# University of Kentucky<sup>®</sup>

CCK-2564.0-9-24

Construct Health Education Building

ADDENDUM #3

**C** TYPICAL TENSION ROCK ANCHOR DETAIL  
NOT TO SCALE

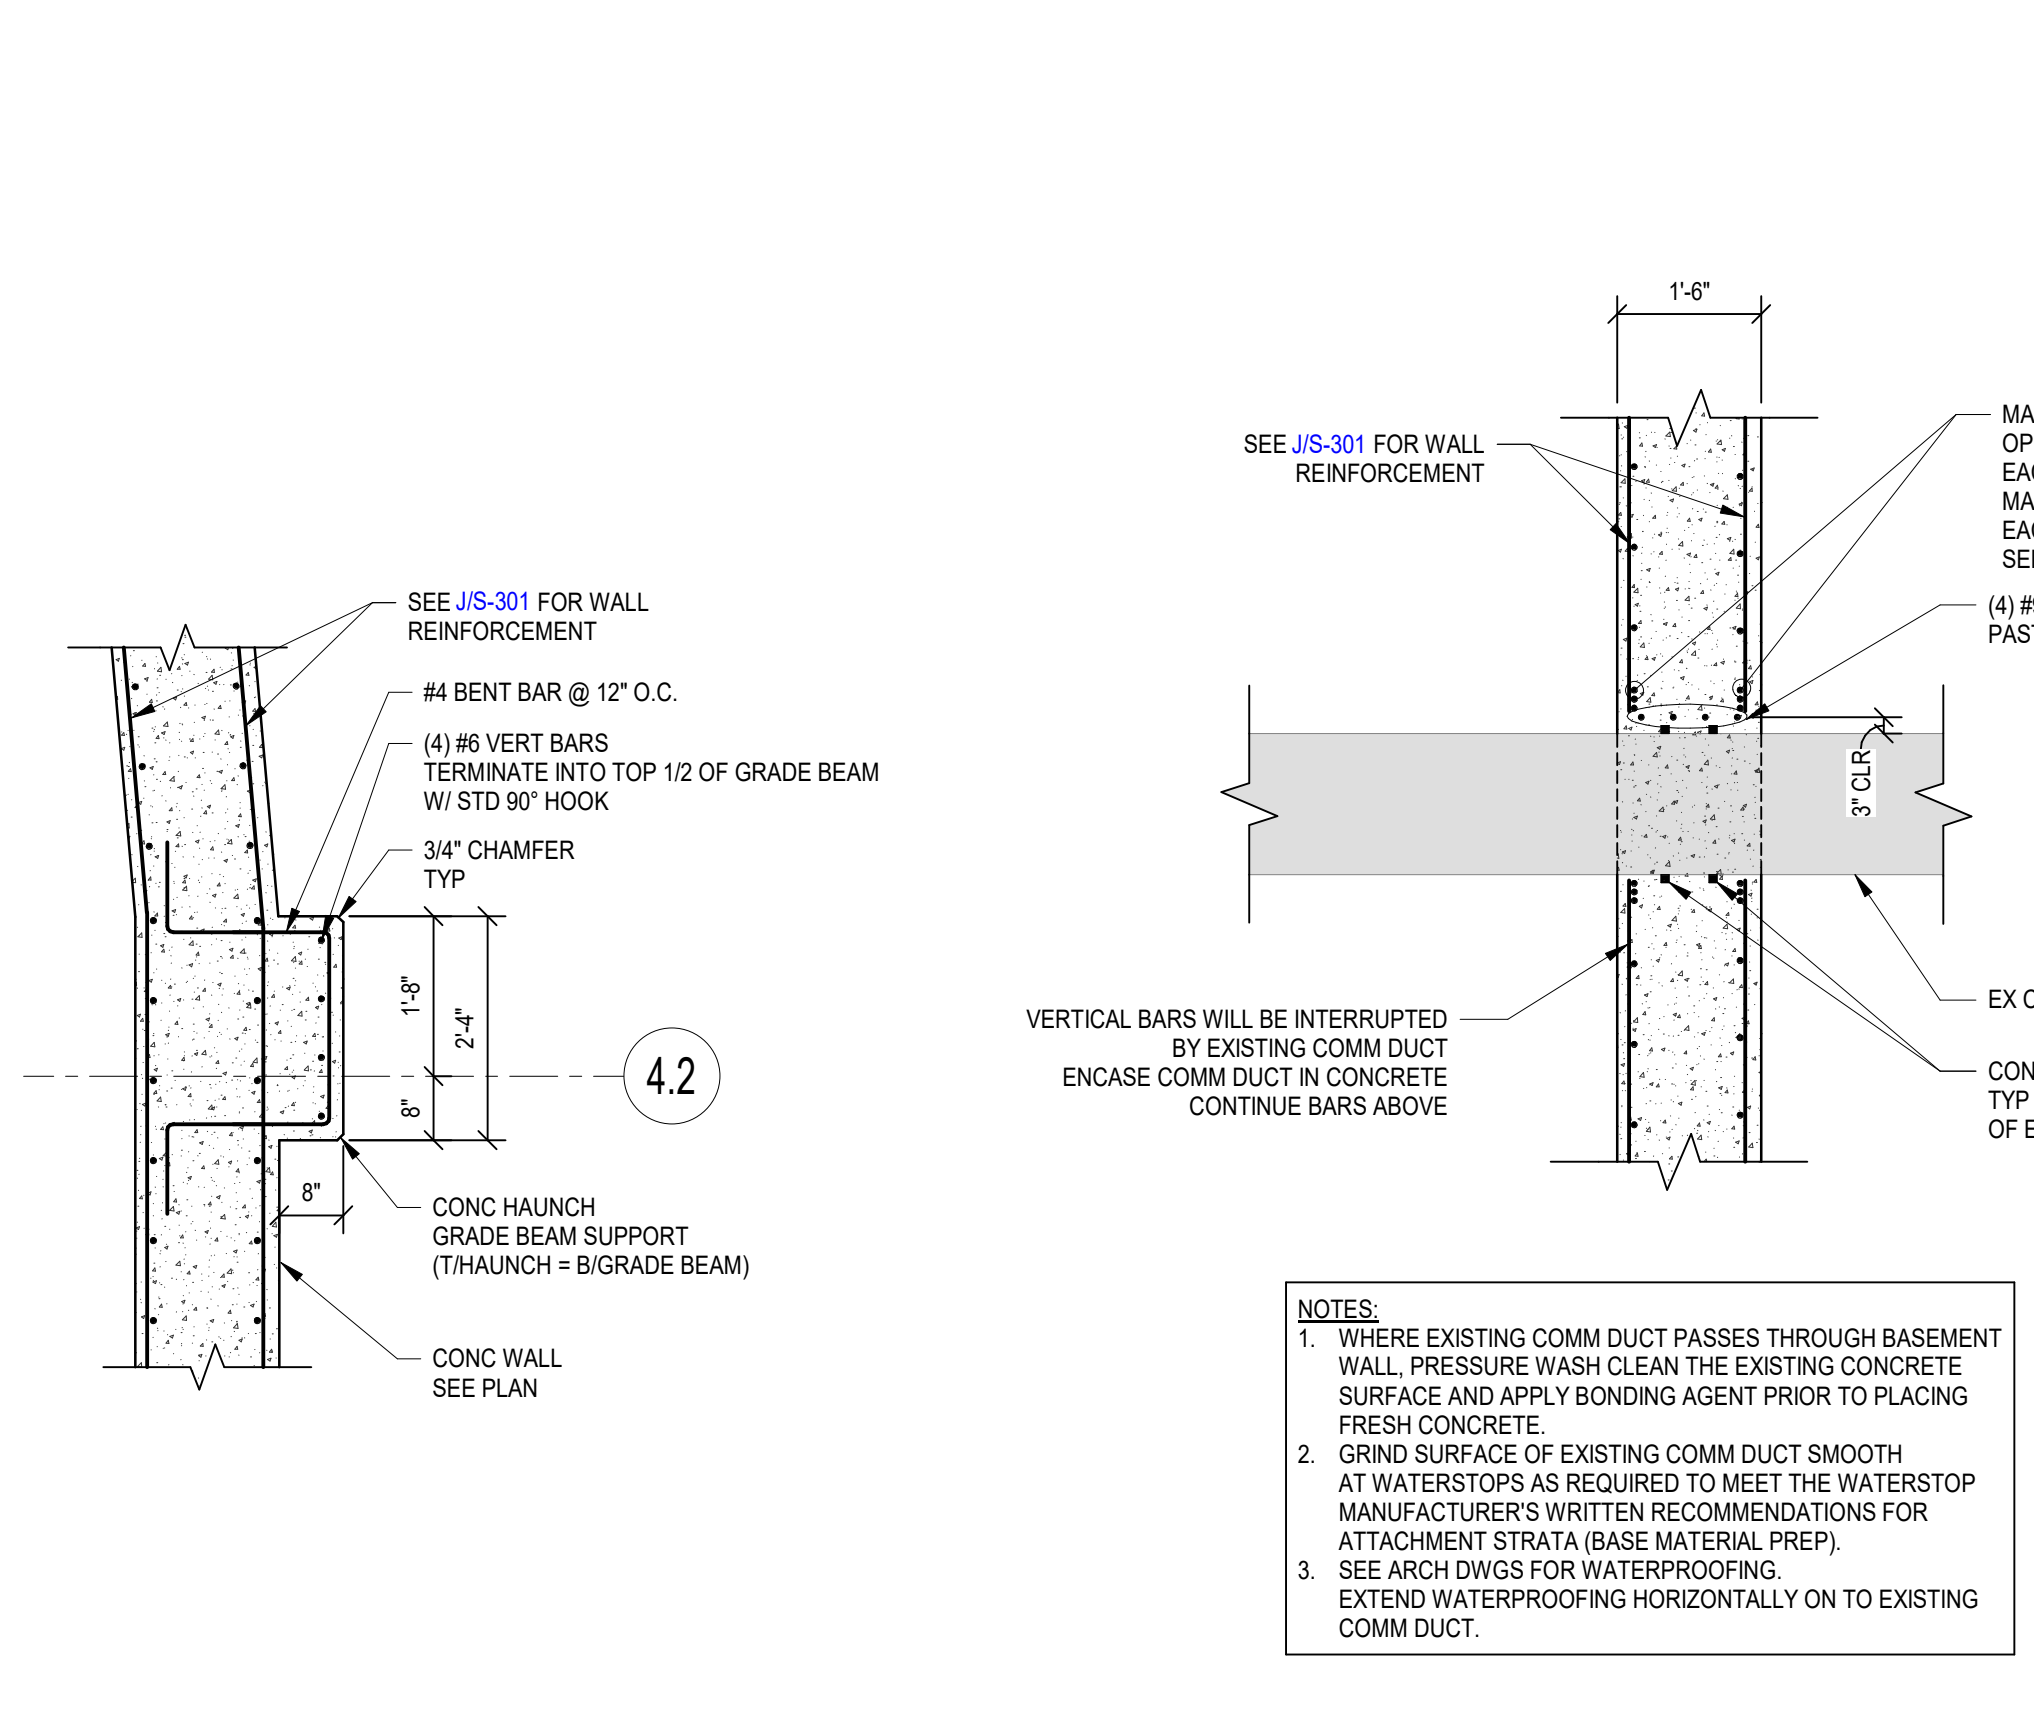
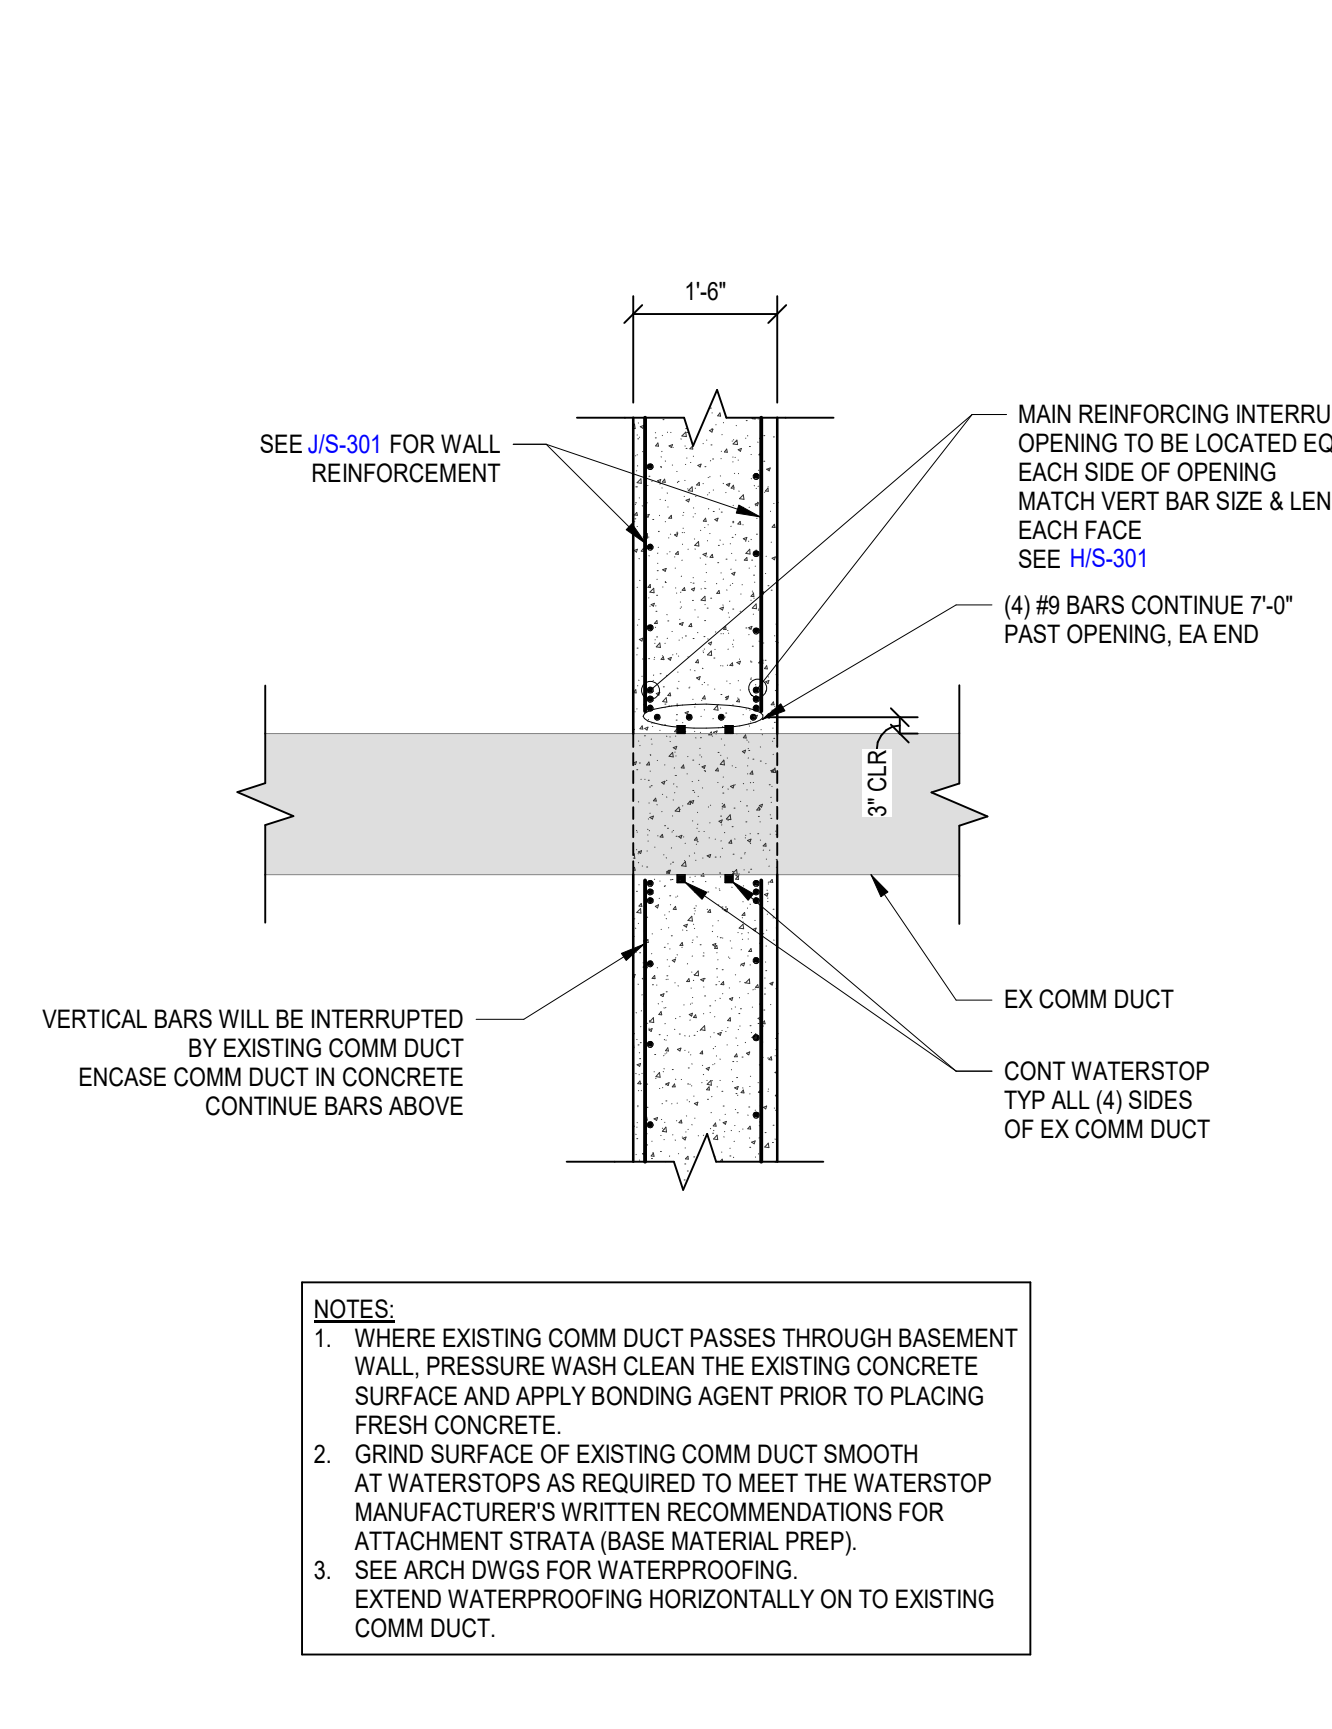
Refer to attached sheet S-302. Updated pier sizes and reinforcement. Added additional pier types.
